REMARKS / ARGUMENTS

Claims 1-9 remain in the application. Claim 1 has been amended.

Amendment to the drawings:

FIG. 1

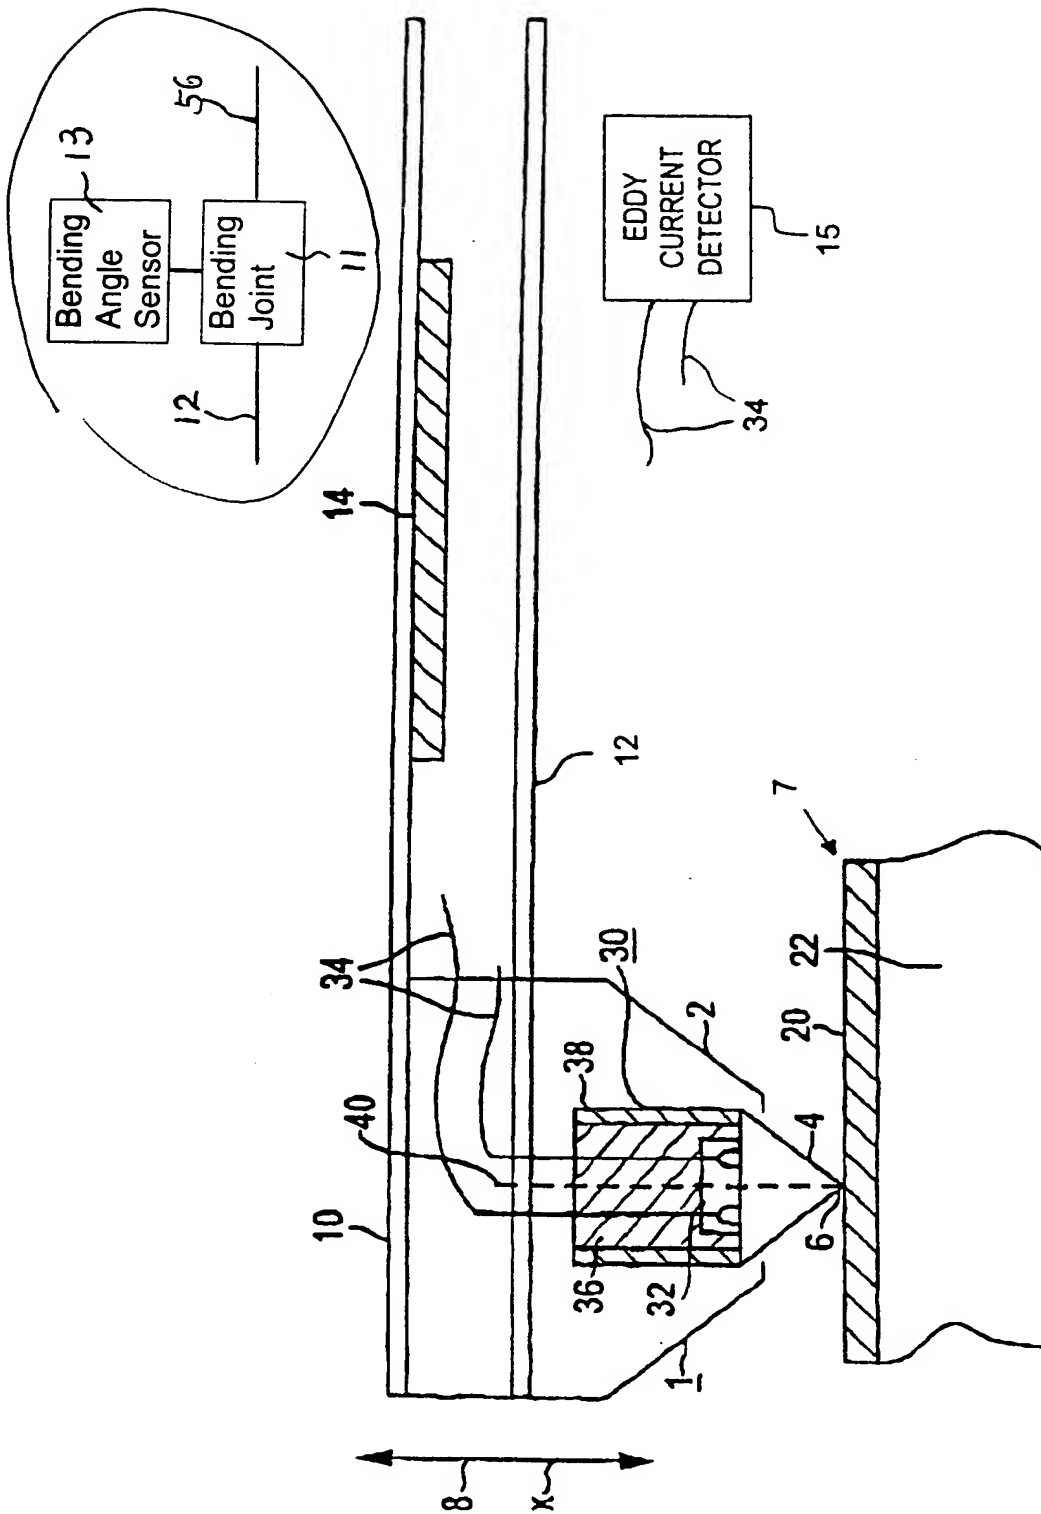
In item 3 on page 4 of the above-identified Office action, the drawings have been objected to under 37 CFR 1.83(a) as not showing every feature of the invention specified in the claims.

More specifically, the Examiner has stated that the bending angle sensor and the bending point recited in claim 5 must be shown or the feature(s) cancelled from the claim(s).

Fig. 1 has been amended to symbolically show the bending joint 11 and the bending angle sensor 13. The specification has been amended accordingly.

This sheet, which includes Fig. 1, replaces the original sheet including Fig. 1. In Fig. 1, a bending joint 11 and a bending angle sensor 13 have now been symbolically shown.
